Charlotte Department of Transportation

Memorandum

Subject: Rezoning Petition 13-085: Approximately 89.5 acres located on the east side of Providence Road between Golf Links Drive and Chancelot Lane.

Figure 1: Additional street connection at the proposed roundabout

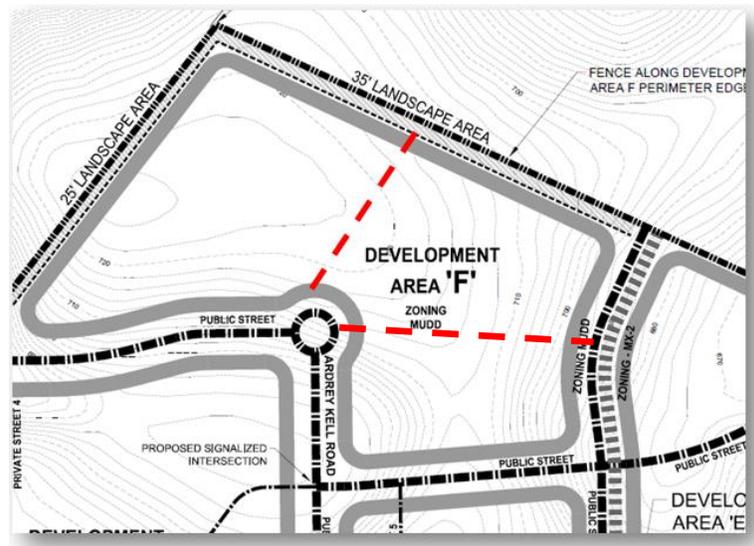
1. The current rezoning petition does not specify the proposed street cross-sections for the internal public and private streets. It is our understanding that the proposed street cross-sections will need to comply with the minimum requirements of the Subdivision Ordinance.
2. A minimum 70' right-of-way needs to be shown for the proposed Ardrey Kell Minor Thoroughfare extension that traverses the subject site.
3. It appears that an additional three (3) street stubs with a maximum of 650' block spacing will be required on the north and east property lines per the Subdivision Ordinance. This will include an additional westbound public street approach from the proposed roundabout through the proposed multi-family development "Area F" (Figure 1).

Figure 3: Proposed Realigned Private Street 4

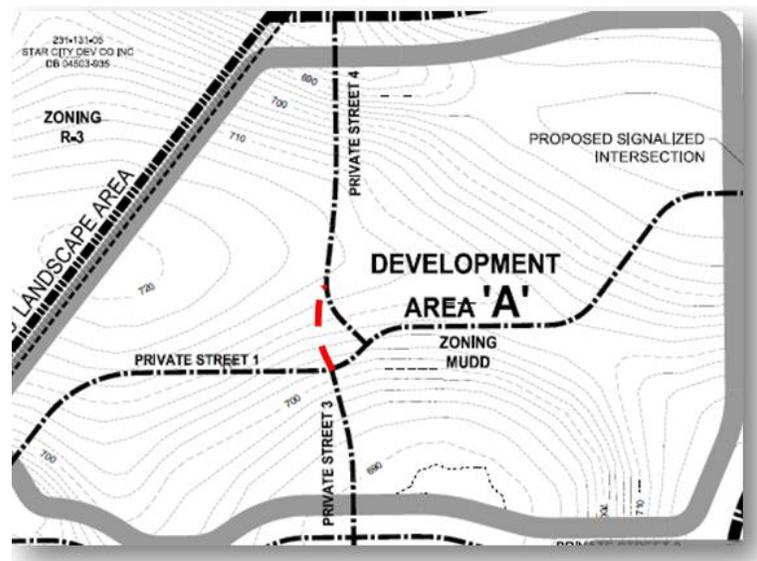
1. We request the petitioner provide cross access between the subject site and the neighboring day care (Parcel #23116108).
2. We request the petitioner realign the stub of Providence Country Club Drive at the east property line (adjacent to the southernmost pond) to prevent any future street extension onto parcel #parallel to the existing stream (Figure 2).
3. We request the petitioner realign private street 4 as depicted in Figure 3 to eliminate the proposed offset at the intersection with Private Street 1.
4. We recommend consideration of an additional single-lane roundabout at the intersection Ardrey Kell and private street 4 in order to balance the traffic volumes in network by making street 4 a more viable way of connecting with the thoroughfare extension of Ardrey Kell to the east.
